Group:	SERVICE MANUAL UPDATE
Bulletin No:	SB-16-031
Issue Date:	11-8-2016

Subject: CORRECTION OF WORKSHOP MANUAL FOR HINO300 SERIES Revision of Troubleshooting Procedure for the DTC P20DF

RELEVANT MODEL: 2015MY COE Trucks

2-896

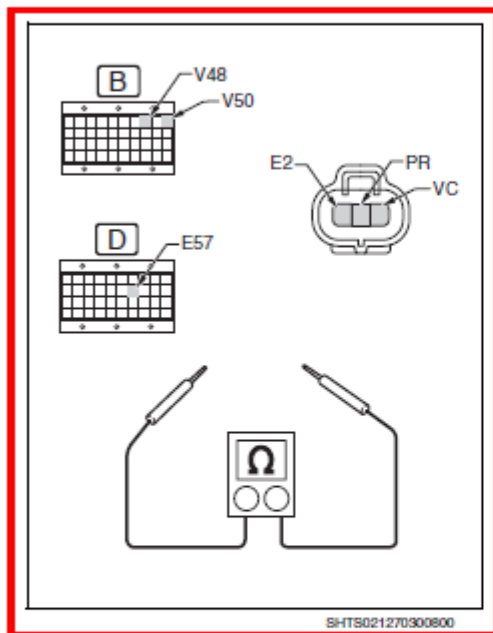
Changed a measurement terminal of DTC P20DF.

CHANGE

CHANGE

4 Inspect the aftertreatment fuel injection line pressure sensor wire harness for disconnection

1. Using the electrical tester, measure the resistance from the engine ECU (signal check harness) to the terminals of the aftertreatment fuel injection line pressure sensor vehicle side connector.

Measurement conditions	Tester connections	Standard values
Starter key: LOCK	Engine ECU (signal check harness) – Aftertreatment fuel injection line pressure sensor vehicle side connector VCPA (V50) terminal – VC terminal FPR (V48) terminal – PR terminal E3 (E57) terminal – E2 terminal	1 Ω
